Subject: NABORS Landfill - Three Brothers, Baxter County, Arkansas

RE: NABORS Landfill - Three Brothers, Baxter County, Arkansas

Response to ADEQ Letters and Request for Information

Photograph 7: Tear in ClosureTurf® near LCS-4.

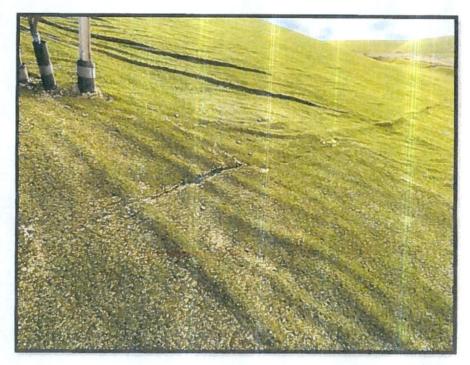
Specifically, Harbor Environmental reported that an apparent tear had developed along a seam of the ClosureTurf lining on the south slope of Area 1-2 or near the LCS-4 control panel. While no intrusive activity is apparent at this time, this issue may impact the integrity of the ClosureTurf cover if not addressed promptly.

1) WG will conduct a site inspection and determine the course of action to quickly repair the compromised seam on the south slope of Area 1-2 near the LCS-4 control panel.
